ARCHITECTURAL REVIEW COMMITTEE MEMORANDUM

DATE: APRIL 15, 2024 **NEW BUSINESS**

SUBJECT: AN APPLICATION BY SELENE PALM SPRINGS, LLC, SEEKING ARCHITECTURAL APPROVAL OF AN AMENDMENT TO THE PREVIOUSLY APPROVED FINAL DEVELOPMENT PLANS FOR THE DREAM HOTEL LOCATED AT THE NORTHWEST CORNER OF AVENIDA CABALLEROS AND AMADO ROAD (APN 508-034-020); ZONE PDD 333, SECTION 14 (CASE 5.1132-PD 333 / TTM 35236).

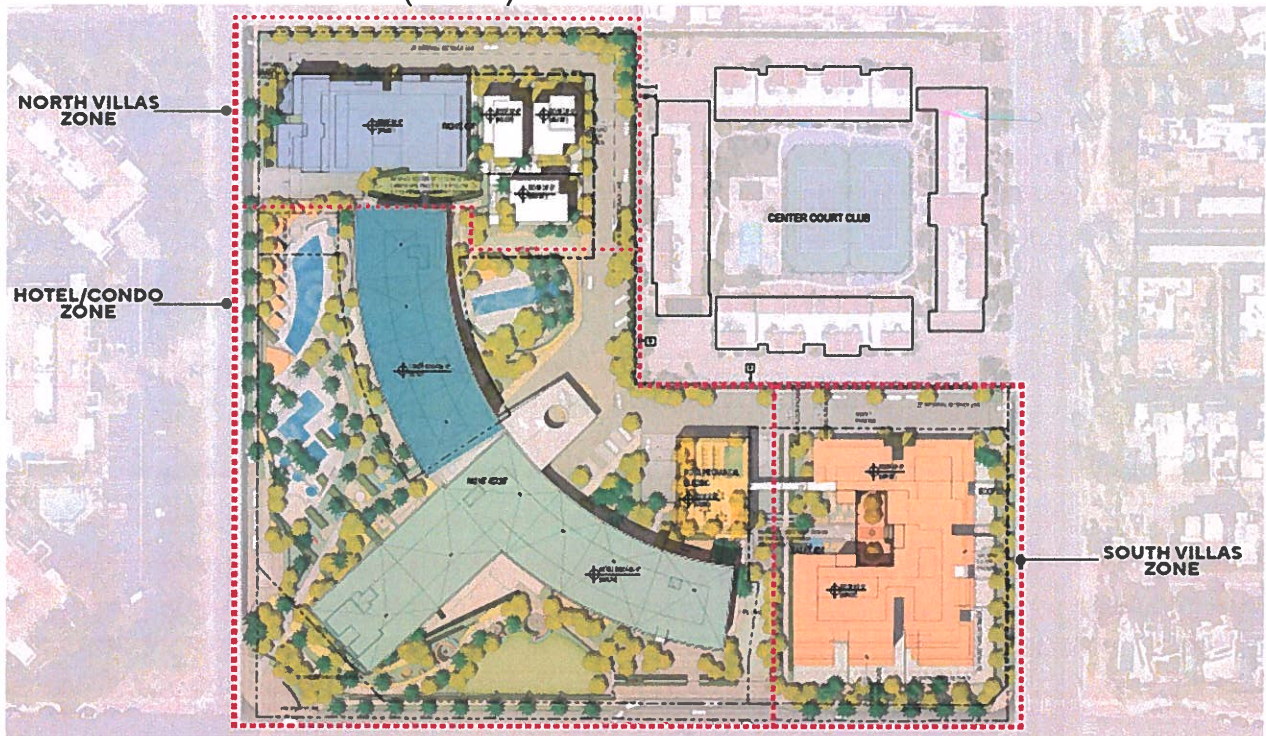
The scope of this review entails the architecture of the North Villa block, the South Villa block, the three townhouses, hotel mechanical building which includes the rooftop pool terrace for the South Villas and the common landscape / open space. A conceptual site plan is shown on the following page shown in comparison with the 6-5-23 submittal.

Basement (subterranean parking) The floor plan has shifted east align with setbacks, is narrower in the north/south dimension, and expanded in length so it now includes parking below the three townhouses.

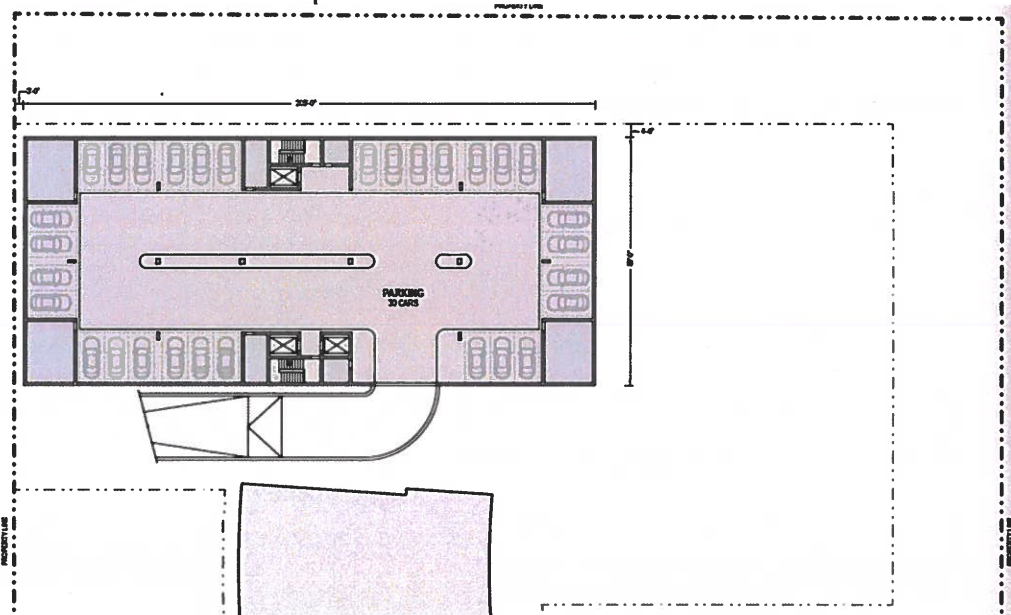
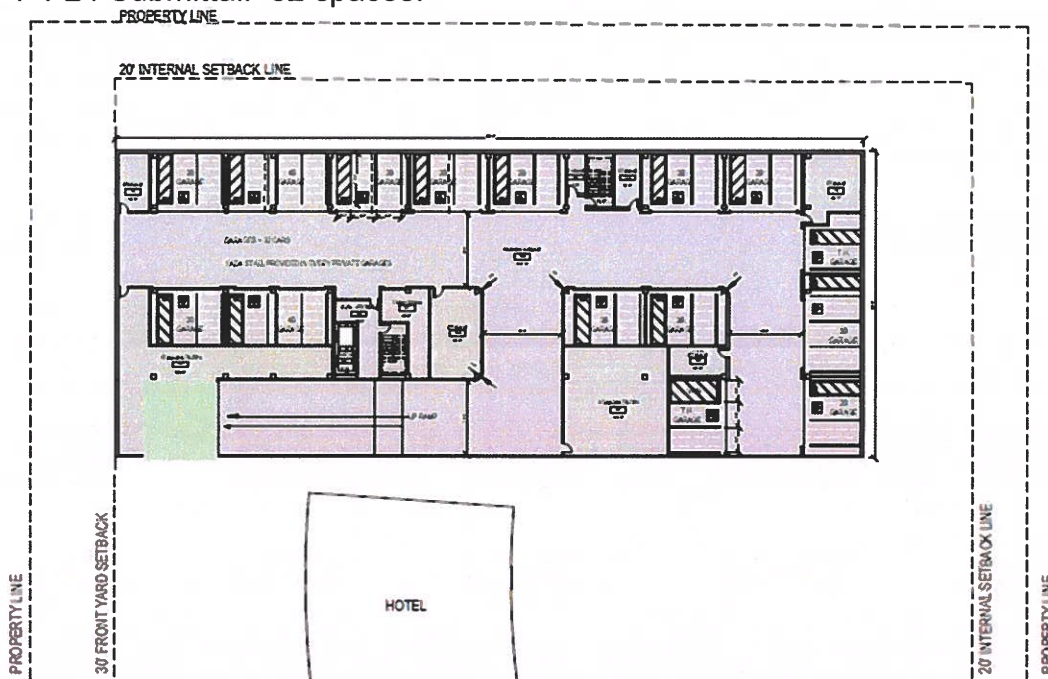
6-5-23 Submittal: 30 spaces.

4-4-24 Submittal: 32 spaces.

Third Floor Plan: The third floor footprint on the 4-4-24 submittal is larger than that shown at the 6-5-23 City Council Meeting and it appears less space is available between the three townhouse units on the current proposal.

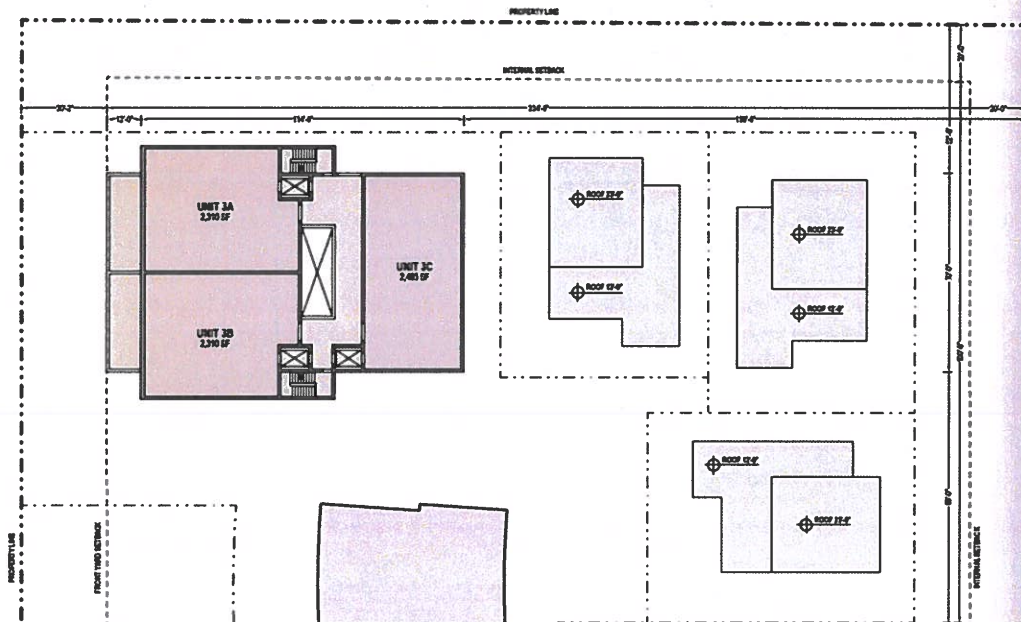
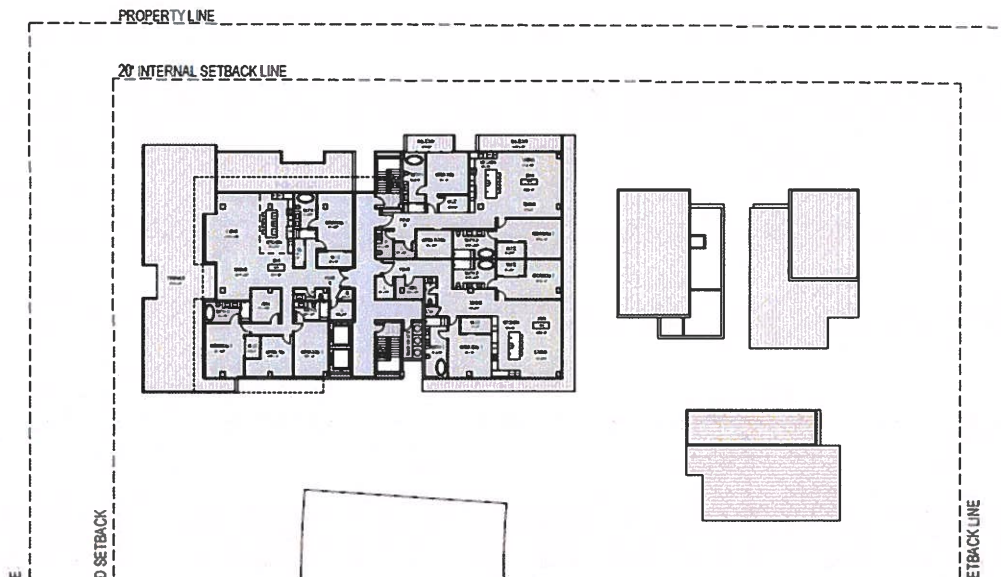
3. Although the three townhouses are in the general location shown on the 6-5-23 submittal, they have been moved closer to one another leaving very little usable space between units. Consider shifting the two "side-by-side" townhouse units at the northeast corner of the site to either be connected or further apart to provide more usable outdoor space around these dwellings as was shown in the 6-5-23 submittal.

Below comparison of the 6-5-23 submittal and the current (4-4-24) submittal; (Note: individual floor plans were not provided in the 6-5-23 submittal so a floor by floor comparison as noted above for the North Villas is not possible.)

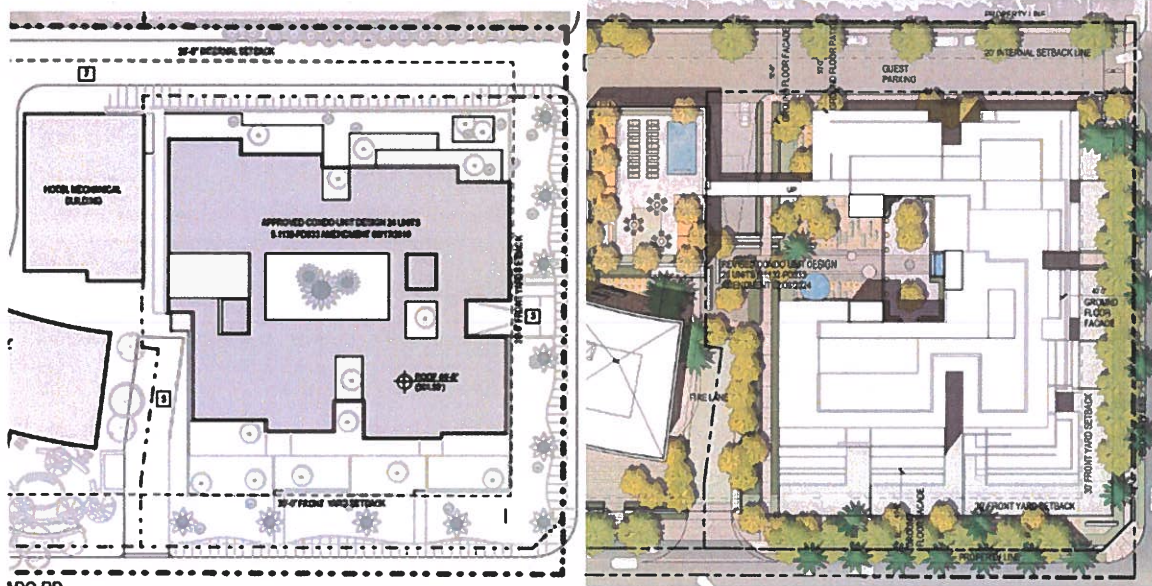
Note no elevations were provided of the hotel mechanical building with the rooftop pool terrace for the South Villas block.

A driveway ramp to the subterranean parking has been provided between the service building and the South Villas block. A rooftop pool terrace has been added to the service building and the building footprint has changed.

7. Provide elevations and sections at the service building just north of the South Villas block which has the pool terrace on the roof for the South Villas block. Consider shade structures on that roof for lounging around the pool.
